Brooklyn Hill Cycling Improvements

90% Design Stage Safe System Audit

Prepared for:
Wellington City Council

Prepared by:
Stantec

Figure 3: Drawing Sheet C307 - Pedestrian Facilities at Brooklyn Road & Washington Avenue Intersection

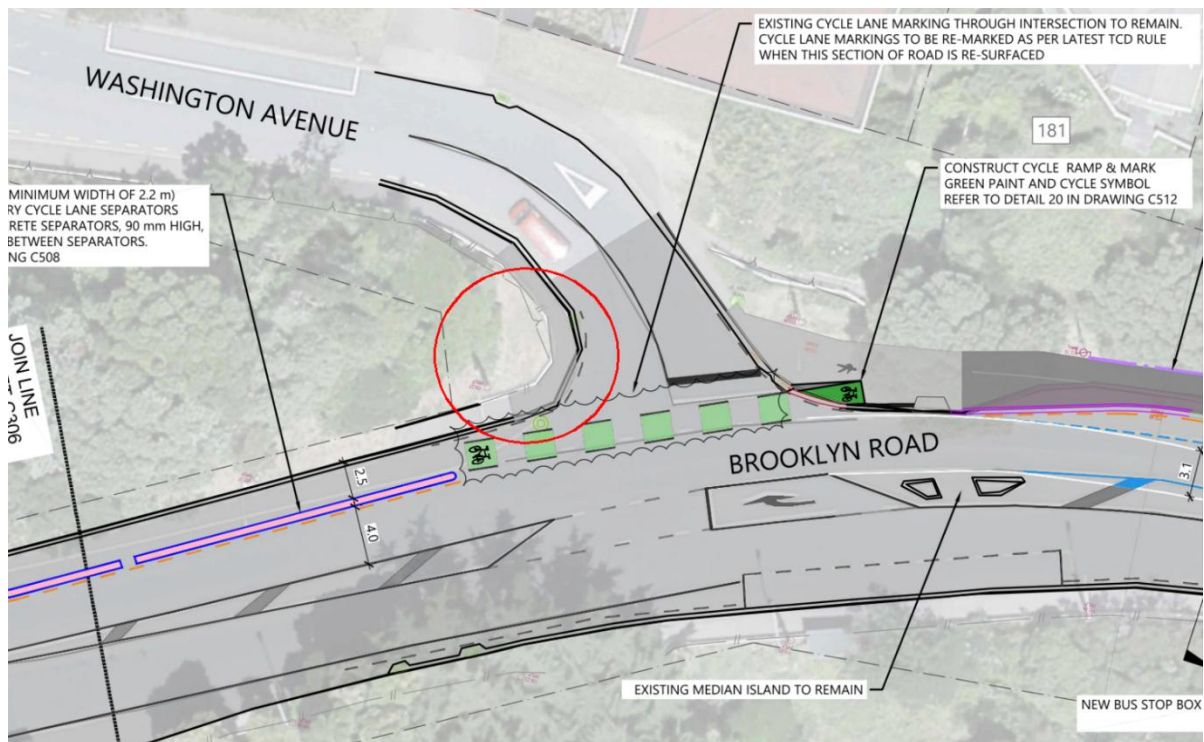
On drawing sheet 307, a footpath is shown southeast of the intersection between Brooklyn Road and Washington Avenue (as shown in **Figure 3**). This footpath should be removed to discourage pedestrians from crossing toward this section, which is not intended as a designated crossing point. Similarly, the dropped kerb located northwest of the intersection, associated with the existing median island, should also be removed to prevent informal pedestrian crossings at that location.

Drivers will be preparing for the pedestrian crossing with the median build-out and may not expect pedestrians to cross immediately. If pedestrians cross prematurely at undesignated points, it may result in slower driver reactions and increase the risk of conflict.

1. Remove dropped kerb to encourage pedestrians to cross at the designated point.
2. Remove the footpath at this location to discourage unsafe crossings and guide pedestrians to safer, designated crossing points on Washington Avenue

| Design team response | <p>1. Partially agree. The dropped kerb at the access to central park can be replaced with a standard kerb & channel. However, consideration is to be given if this access is used by cyclists (green paint can be added to the dropped kerb and length of the dropped kerb can be reduced to discourage pedestrian use of this drop kerb and keep it for cyclists use)</p> <p>Further investigation is required to confirm if this access is used by cyclists.</p>  <p>2. Partially agree. The footpath along the eastbound lane of Washington Avenue currently leads to a dead end at Brooklyn Road. While a portion of this footpath could be removed near Brooklyn Road, removing the entire section along the eastern kerb would create safety risks. In that scenario, pedestrians would be forced to cross Washington Avenue further upstream, where drivers are not expecting pedestrians to enter the roadway. This could reduce driver reaction time and increase the likelihood of crashes.</p> <p>It is relatively safer for pedestrians to cross at the intersection, where drivers are already on higher alert due to the continuous cycle lane and intersection activity.</p> <p>As an alternative, consideration could be given to a dedicated pedestrian crossing adjacent to the cycle lane crossing at the intersection. However, introducing such a crossing is outside the current scope of this project.</p> |
| Client safety engineer comment | <p>Agree with Designer's response.</p> <p>Consider a dedicated pedestrian crossing adjacent to the cycle lane crossing at the intersection</p> |
| Client decision | <p>Drop kerb to remain for access to Central Park by PSR maintenance vehicles and for cyclists. T&I minor works programme to consider a dedicated pedestrian crossing adjacent to the cycle lane crossing at the intersection. Follow up on minor works programme to occur.</p> |
| Action taken | <p>No action within this project. T&I Minor Works programme to consider a dedicated pedestrian crossing adjacent to the cycle lane crossing at the intersection.</p> |

Figure 4: Drawing Sheet C305 - Missing Cycle Signage

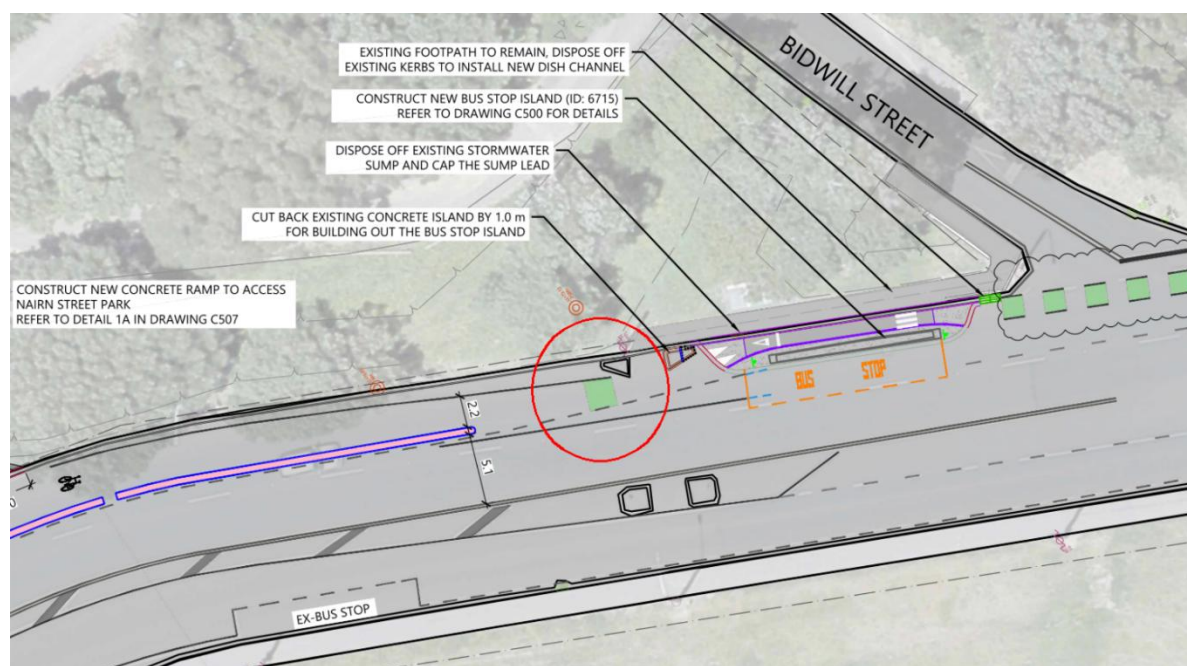
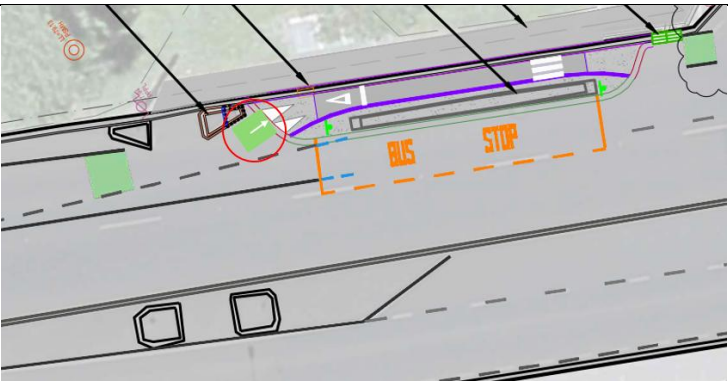
On drawing sheet C305, on Brooklyn Road just before the intersection with Bidwill Street, green surfacing is shown to indicate the presence of a cycle way. However, the absence of a cycle symbol on the green surfacing (as shown in **Figure 4**) may create ambiguity for both cyclist and bus drivers, particularly as it is located just before the bus stop, where buses begin to merge left to reach the designated stopping area.

1. Add a cycle symbol to the green-painted area to clearly indicate the presence of a cycle way and improve wayfinding for cyclists.

| Design team response | Agreed, A cycle symbol can be added over the existing green paint, and an additional green treatment with a directional arrow can be applied just before the cycle ramp on the bus stop island (see snip below). This will help reinforce the intended travel direction for cyclists and improve overall legibility of the facility. |

| Client safety engineer comment | Agree with Designer response. |
| Client decision | Designer to update the drawings with a cycle symbol over the existing green paint, and additional green treatment with a directional arrow just before the cycle ramp on the bus stop island (see snip above). |
| Action taken | Drawings updated |

Figure 5: Drawing Sheet C305 – Shared Path by The Bus Stop

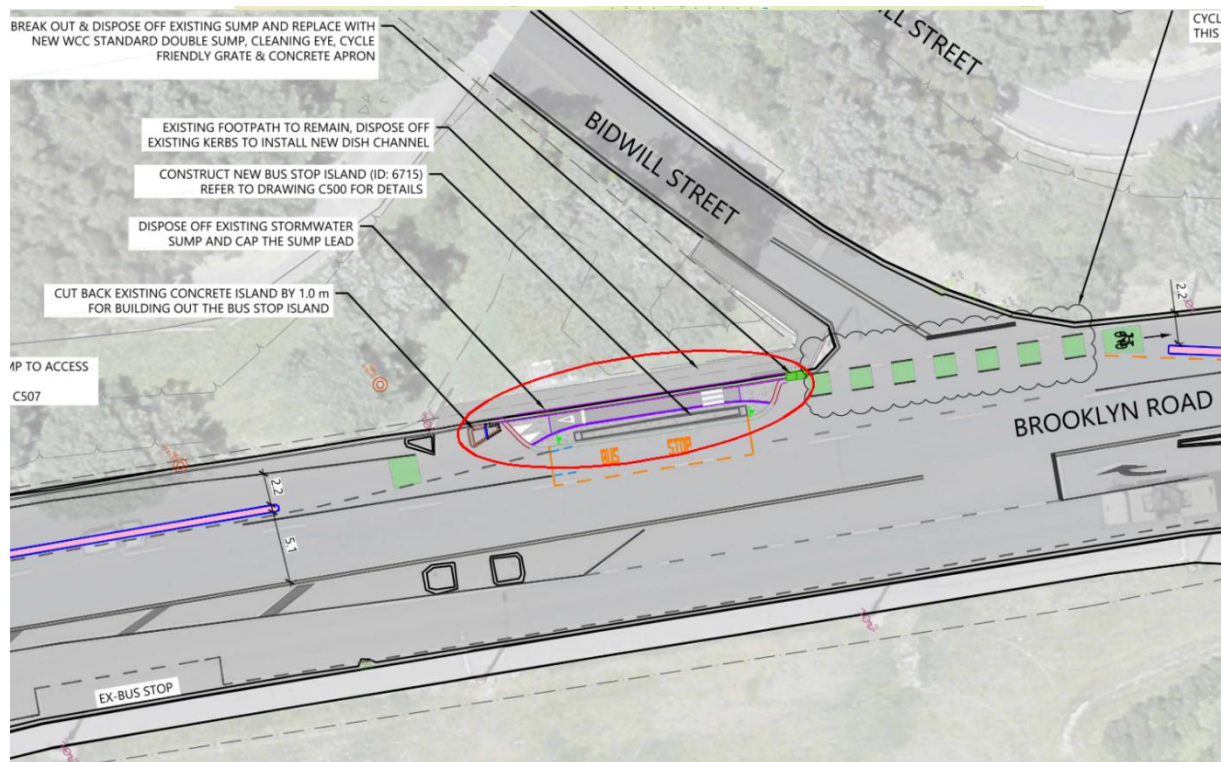
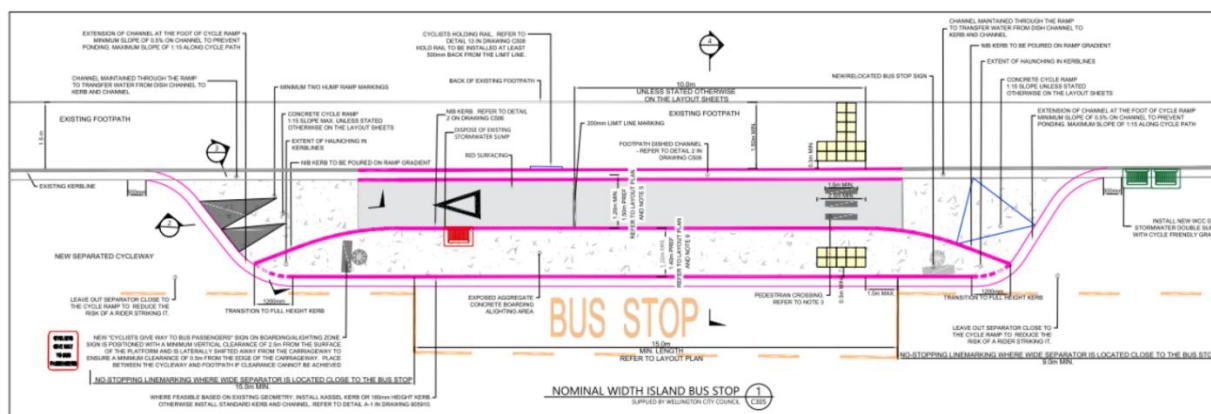
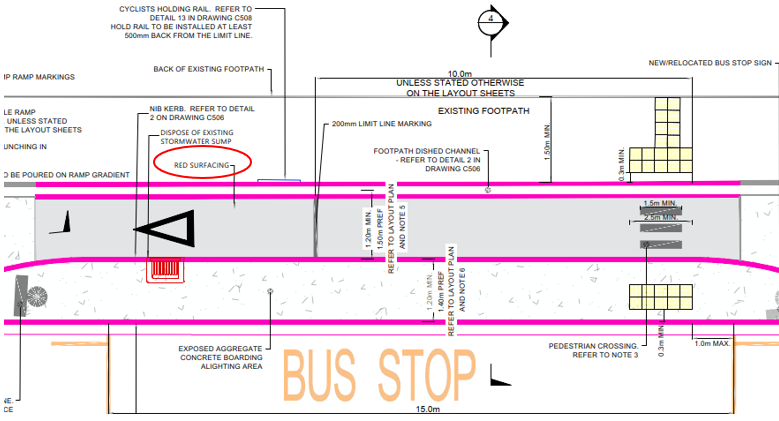
On drawing sheet C305 and 500, a shared path for pedestrians and cyclists is shown adjacent to the bus stop. However, the absence of red surfacing to highlight potential interactions (as shown in **Figure 5** and **Figure 6**) may reduce awareness among users. Without this visual cue, cyclists may not anticipate pedestrians entering or exiting the bus, and pedestrians may not expect cyclists passing through the shared path.

1. Introduce red surfacing on the cycle path adjacent to the bus stop to warn cyclists of pedestrian activity and ensure the white crossing line is flush with the surface to prevent trip hazards.

| Design team response | The red surfacing on the cycle path is already shown on the drawing C500 (Refer below snip) |
| Client safety engineer comment | Agree with Designer response. |
| Client decision | Current NZTA guidance to be applied, designer to retain the red marking already shown on the drawing |
| Action taken | Drawings to remain as they are. |

Figure 7: Drawing Sheet C305 - Multiple Manholes on Cycle Way

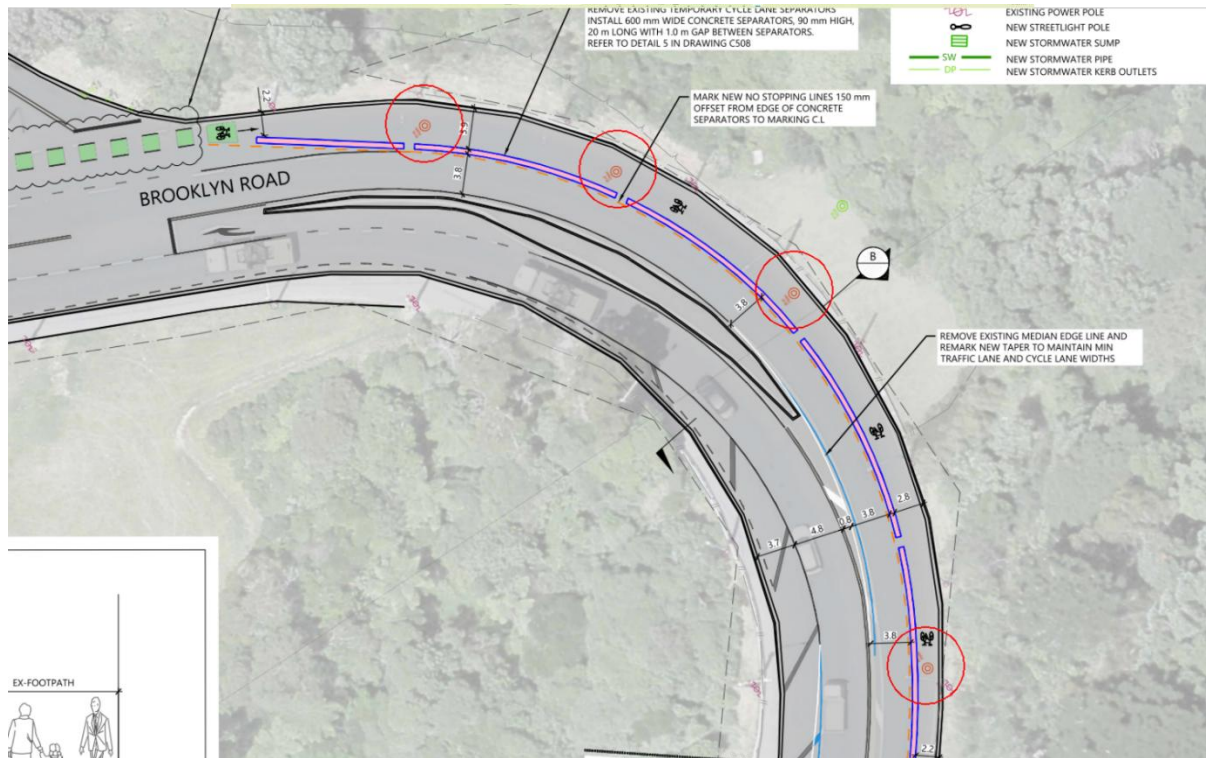
On Drawing sheet C305 and C306, several manholes are located along the cycle way (as shown in **Figure 7** and **Figure 8**). These surfaces can become slippery, particularly in wet conditions, posing a safety risk for cyclists. The reduced traction may lead to loss of control or falls, especially when cyclists are required to navigate over or around these features.

1. Use non-slip surfacing treatments on the manholes to ensure safe passage for cyclists in all weather conditions.

| Design team response | Agreed. A non-slip surfacing treatment can be applied to the manhole lids and service chamber covers located within the cycle lane to enhance safety and reduce the risk of skidding. |
| Client safety engineer comment | Agree with Designer response. |
| Client decision | Designer to specify on drawings that non-slip surfacing treatment be applied to the manhole lids and service chambers located within the cycle lane during construction |
| Action taken | Instruction to contractor added to drawings |

Figure 9: Drawing Sheet 301 - Stormwater sump on Cycle Way

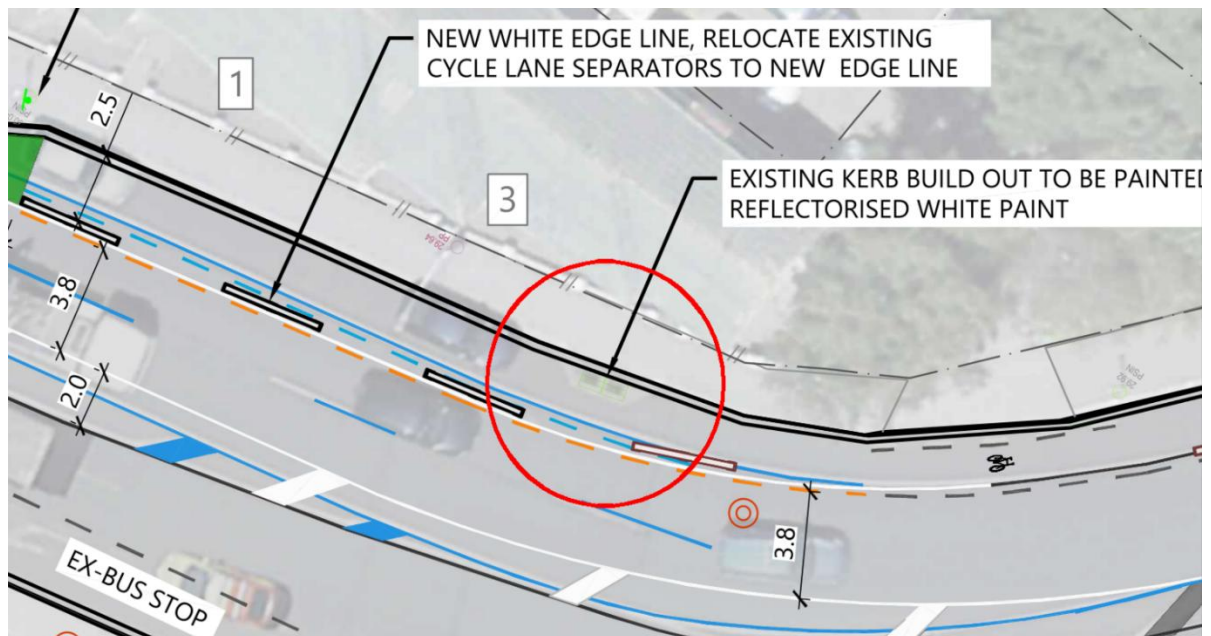
On drawing sheet C301, a stormwater sump is shown within the cycle way (as shown in **Figure 9**). During the site visit, the audit team assessed the remaining usable width and found that the sump's placement presents multiple concerns. In addition to potential safety risks from uneven or slippery surfaces, the sump significantly reduces the effective width of the cycle path. This narrowing may restrict safe passing and manoeuvring for cyclists, particularly in areas with higher cyclist volumes or limited space.

1. Ensure that all stormwater sumps located within the cycle way are fitted with bicycle-friendly, non-slip grates and are flush with the surrounding surface to maintain a smooth and safe riding experience.
2. Where feasible, consider relocating or redesigning the sump to preserve the full width of the cycle way and maintain a safe, unobstructed path for cyclists.

| Design team response | Agreed, The stormwater sump can be replaced with a cycle-friendly, non-slip grate that is flush with the surrounding surface to improve safety and comfort for cyclists. |
| Client safety engineer comment | Agree with Designer response. |
| Client decision | Recommendation number 1 - Designer to update the drawings to reflect the stormwater sump to be replaced with a cycle-friendly non-slip grate that is flush with the surrounding surface. Recommendation number 2 – Altering the sump location will be a costly change, which is out of scope for this project |
| Action taken | Drawings updated |

Figure 15: Lack of vertical indicators at Nairn Street

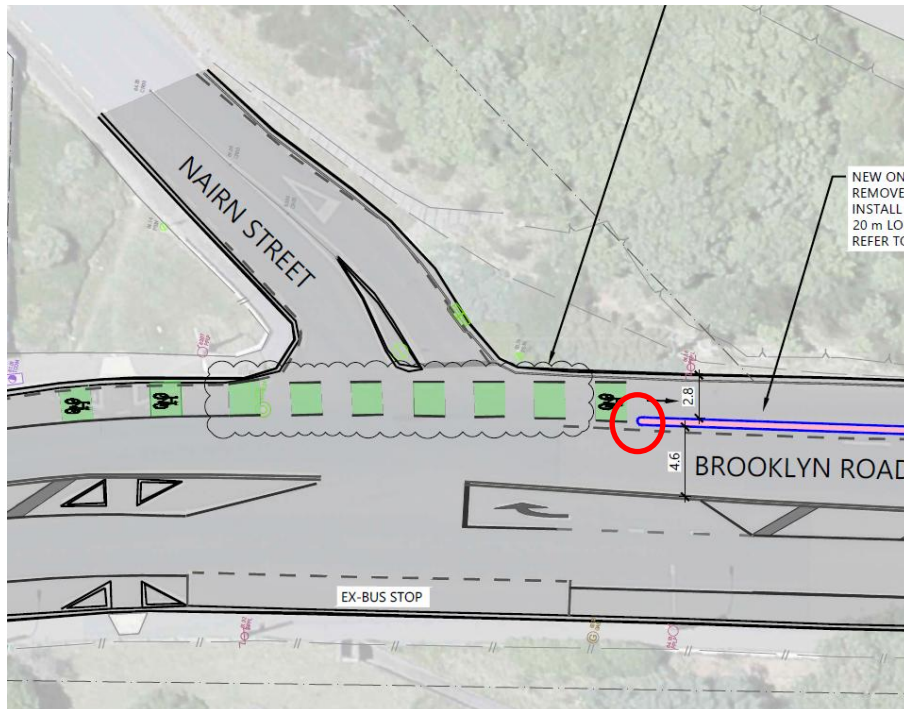
While on-site, the audit team identified two instances where there are new cycle lane separators that are proposed to be installed but there are no vertical indicators provided at their commencement to assist drivers in identifying the separators. This increases the risk of drivers not noticing the separators and driving over them. This risk will be increased at locations where drivers turn left out of

the side street while looking right to filter into a gap while not noticing the proximity of the cycle lane separator.

1. Install several safe hit bollards or similar at the start of the cycle lane separator where it might be struck by an errant motorist.

| Design team response | Agreed. Safe-hit posts, such as Vanguard's Ultraflex delineator posts, can be installed at the start of the cycle lane separators in locations with a higher risk of impact from errant motorists. This would provide added protection for cyclists while maintaining clear lane delineation. |
| Client safety engineer comment | Agree with Designer response. Check that the use of delineator posts at these locations is consistent with related T and I maintenance guidelines. |
| Client decision | Designer to update drawings to indicate that Vanguard Ultraflex delineator posts are installed at the start of the cycle lane separators in location with a higher risk of impact from errant motorists |
| Action taken | Drawings updated |

Figure 17: Drawing Sheet C308 - Removal of Green Surfacing on Cycle Way

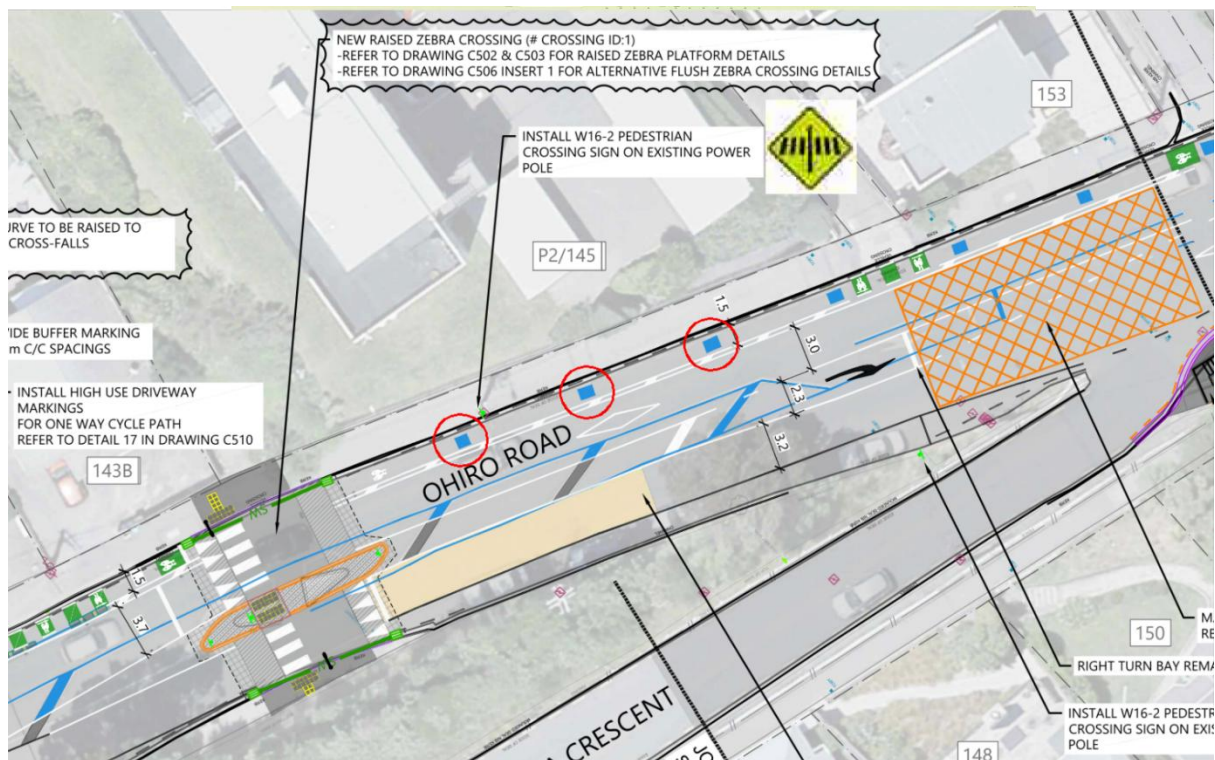
Drawing sheet C308 indicates that some green surfacing on cycle way will be removed (as shown in **Figure 17**). This could lead to confusion for drivers, who may inadvertently merge into the cycle lane, and reduce visibility for cyclists.

1. Retain the green cycle lane markings to maintain clear separation between vehicle and cyclist paths and enhance safety for all road users.

| Design team response | Agreed. Existing green markings on the cycle lane can be retained. |
| Client safety engineer comment | Agree with Designer response. |
| Client decision | Drawings to be updated to indicate that existing green markings on the cycle lane to be retained |

Drawings updated
